SDC-91-00027

SUGGESTED MODIFICATIONS TO Si LAYOUT
PROPOSED 4/15/91 BY H. ZIOCK

M. Strovink

April 30, 1991

H. Ziock 4/15/91

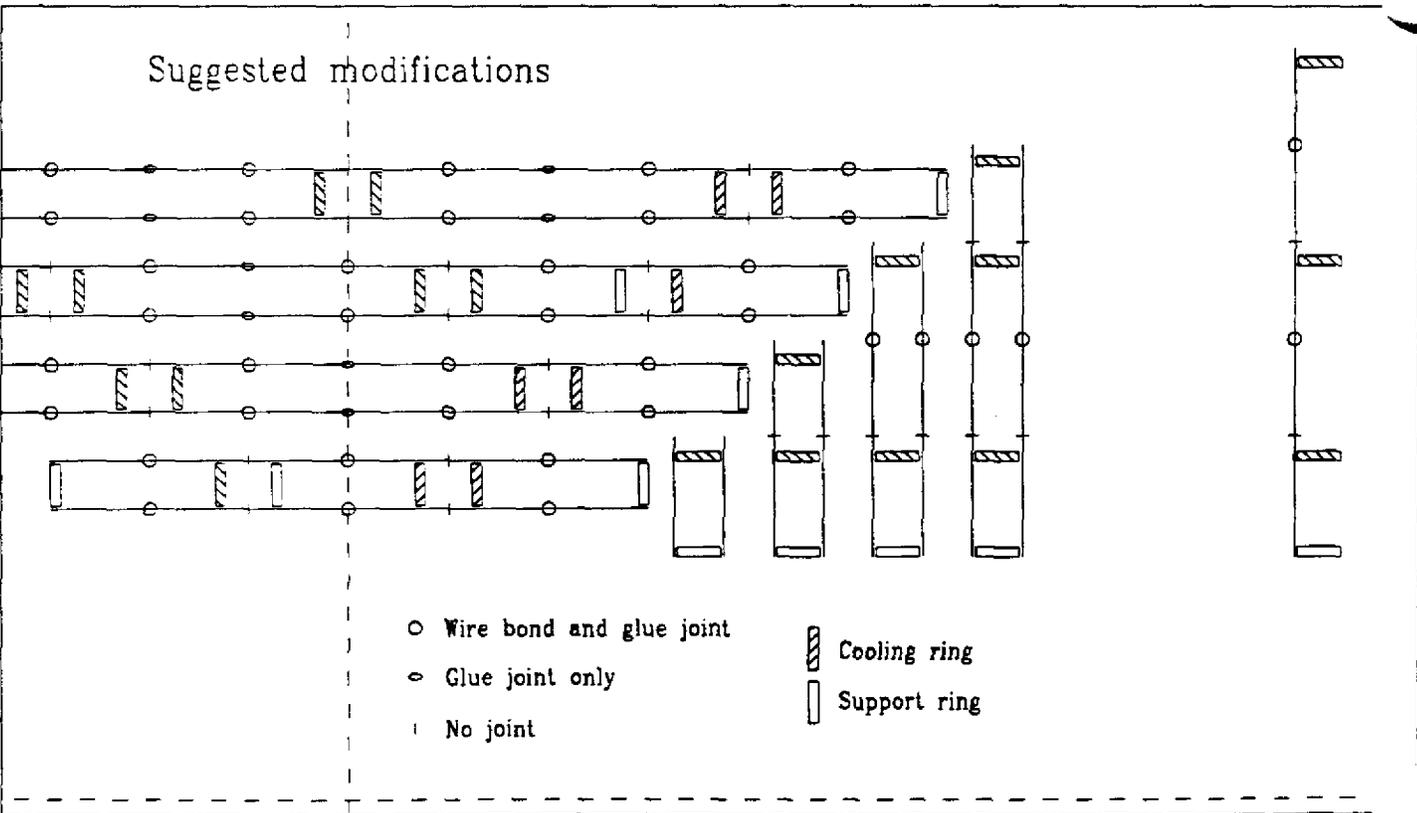
Suggested modifications

- Remove 3 cm from each end of the even barrel layers.
- Make disks 2, 4, 6, and 8 identical in inner and outer radii, respectively, to disks 1, 3, 5, and 7. Move the disk packages closer to $z=0$ by 3 cm.
- Read out the disks at 1, 2, or 3 of 5 radii (21.21, 27.27, 33.33, 39.39, 45.45 cm) rather than 1, 2, or 3 of 3 radii (20.9, 27.3, or 39.5 cm). Then every wedge is read out near r_{\max} .

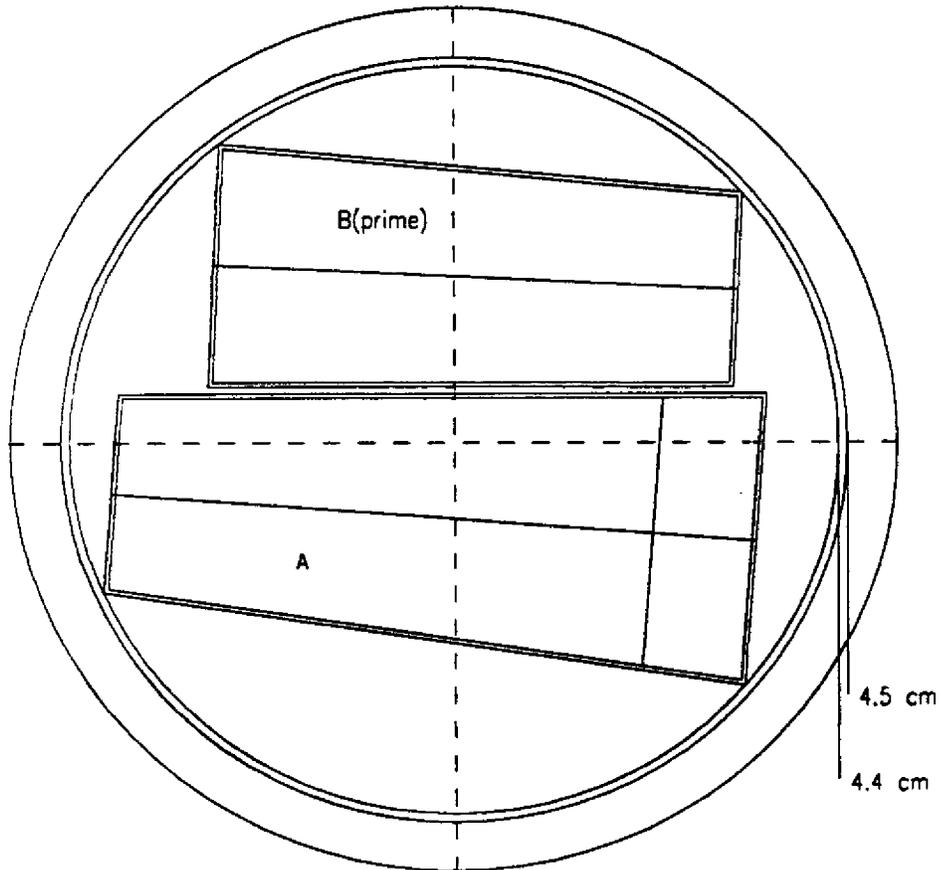
For the mask pairing (*A, B'*); (*B, B'*); (*D, B'*); (*C, C*); and (*D', E*), requiring 5 different wedge detector masks, there would be only 12 "extra" detectors per 5448 produced.
